From: Jones, William V., EMNRD
Sent: Thursday, June 28, 2007 11:48 AM
To: 'Tom Kellahin'; Andrew McCalmont
Cc: Ezeanyim, Richard, EMNRD
Subject: SWD Application on behalf of Chesapeake: Globe 14 Federal #1 API No. 30-015-34755

Well Name/Num: GLOBE 14 FEDERAL #1 Date Spudded: 2006

APPLICATION FOR AUTHORIZATION TO INJECT

CURRENT WELLBORE SCHEMATIC

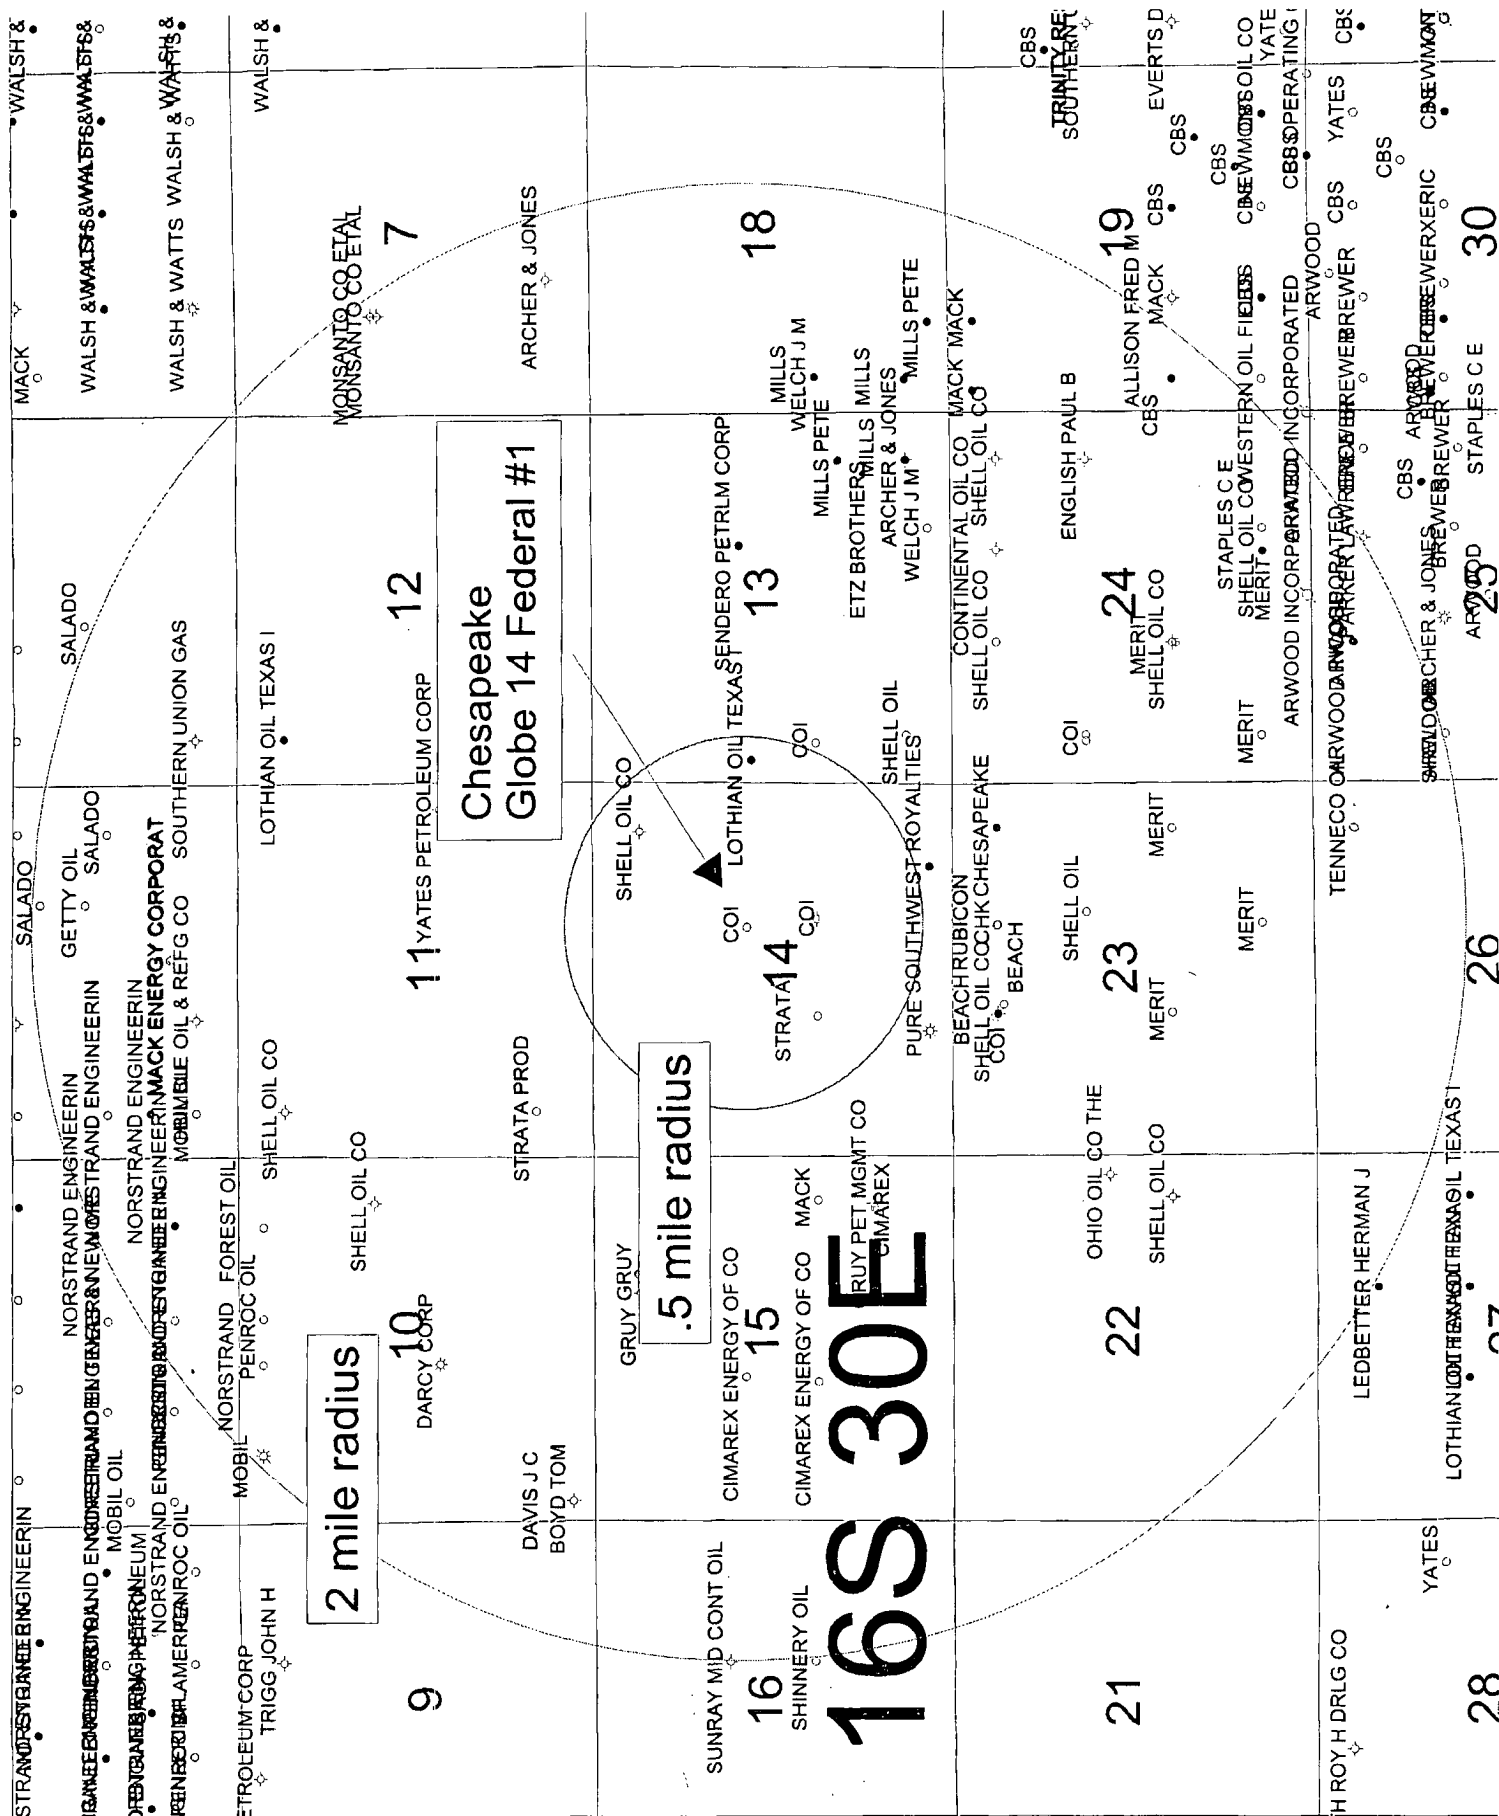
11) Looks like the Dry and Abandoned well API NO. 30-015-10367 needs to be re-entered and re-plugged from the top of the Glorieta at approx 4490 feet to the surface. There was a reason probably this well was not plugged as it was intended? May be some fishing involved - but isn't that always fun? We can make the re-entering and replugging of this well as a condition of an approved permit - but I need a reading from Chesapeake whether they will commit to doing this or not. If re-entry is unsuccessful, the proposed injection permit will be void.

Handwritten notes:
OK
W/ 200 SX

Handwritten note:
REPLUG
TO Below 522'

Workover Proposal

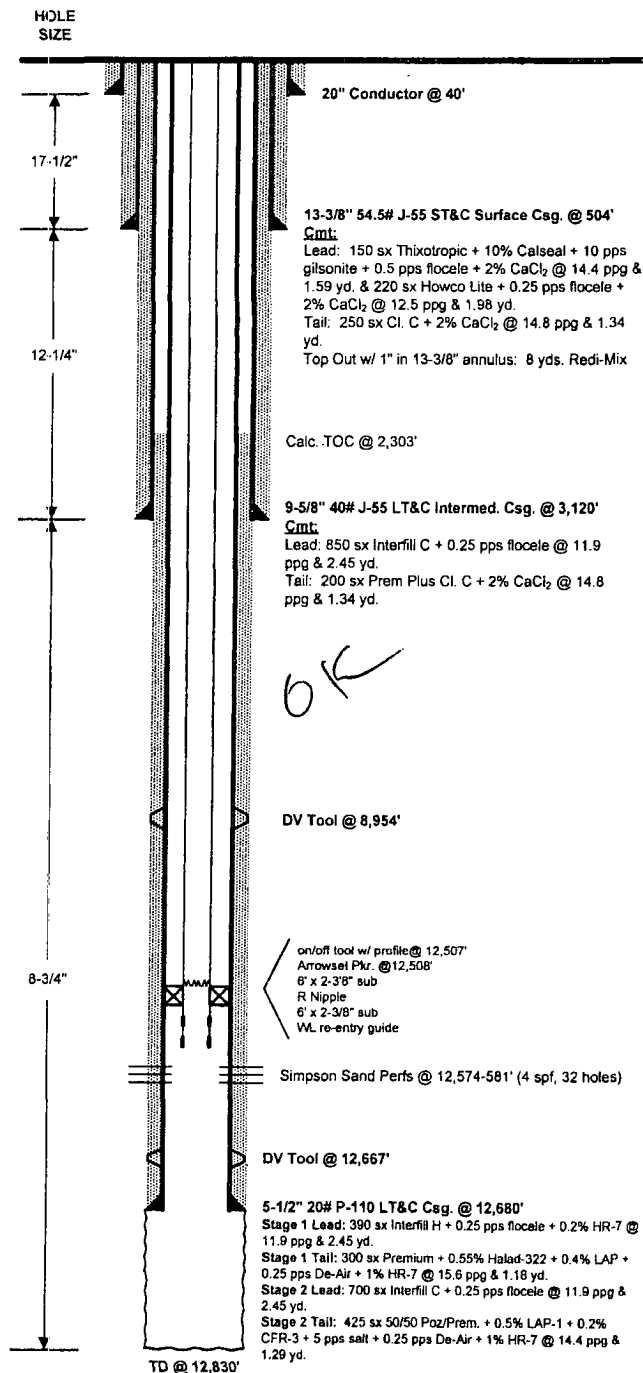
- 4) What is the depth to top and bottom of fresh water in this area - apparently it is in the Roswell Controlled Water Basin
- 5) The OCD wants injection intervals to be isolated as well as possible and will require the well to be plugged back with CIBP to within 200 feet of the lowest perforation.

- 7) Send a copy of the CBL showing the top-of-cement for the 5-1/2 inch casing to me in Santa Fe.
- 8) What is the actual footage location of this well at 3660 feet down? - well file shows it may be a deviated well. Does this new footage location change any Area of Review wells or affected parties?

Set CIBP within 200' of Bottom Perf
